UNITED STATES PATENT AND TRADEMARK OFFICE

APPLICATION NO.	FILING DATE	FIRST NAMED INVENTOR	ATTORNEY DOCKET NO.	CONFIRMATION NO.
10/720,817	11/24/2003	Abhay Sudhakar Rao Kant	133918-1	5358

Office Action Summary

DETAILED ACTION

FIG. 2

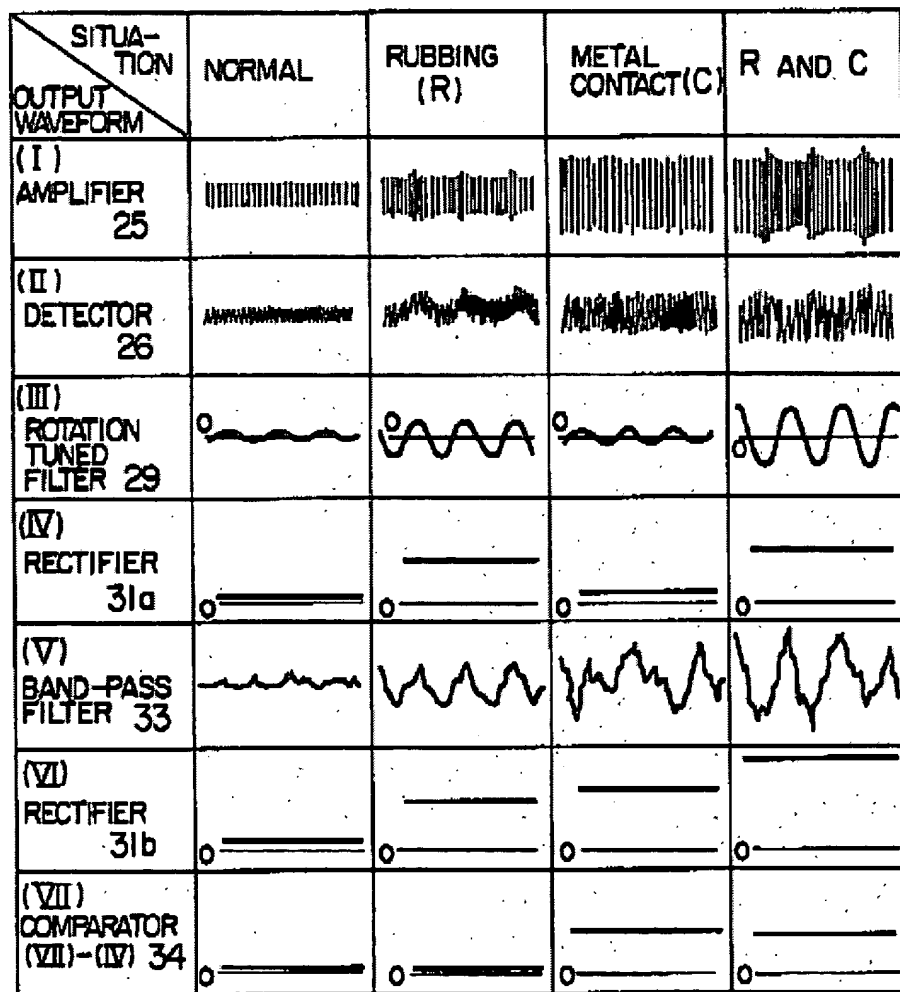
Sato discloses a system for detecting a rub in a turbomachine comprising:
 a turbomachine (Col. 1, Lines 35-39); sensors (fig. 1, unit 4a, 4b)
 monitoring turbomachine conditions (fig. 1, unit 6a, 6b), and an on site
 monitor in communication with the sensors (fig. 2, unit 14), and loaded
 with instructions to implement a method for detecting whether a rub is
 occurring in the turbomachine (fig. 2).

Sato discloses a method for detecting a rub (fig. 2) in a turbomachine (Col. 1, Lines 35-39), the method comprising: monitoring turbomachine conditions (fig. 2), and determining whether a rub is occurring (fig. 2).

occurring in a turbomachine (fig. 2, Col. 1, Lines 35-39), the storage medium including instructions for causing a computer to implement a method (fig. 1, unit 13) comprising: obtaining data indicating turbomachine conditions (fig. 2, Col. 1, Lines 35-39); and determining whether a rub is occurring (fig. 2).

Sato discloses a system, comprising: a turbomachine (fig. 1, fig. 2, Col. 1, Lines 35-39); means for monitoring turbomachine conditions (fig. 2), and means for detecting whether a nub is occurring in the turbomachine (fig. 2).

Sato discloses a system, comprising: a plurality of turbomachine Col. 1, Lines 35-39) sensors (fig. 1, unit 4a, 4b); and a nub detection system configured to monitor the plurality of turbomachine sensors and to detect a turbomachine rub event (fig. 2).

Sato discloses a system, comprising: a rub detection system configured to monitor operational parameters of a turbomachine and to detect a turbomachine rub event (Col. 1, Lines 35-39, fig. 2).

Sato discloses a method, comprising: analyzing turbomachine operational Col. 1, Lines 35-39) data to detect a rub event in the turbomachine (fig. 2).
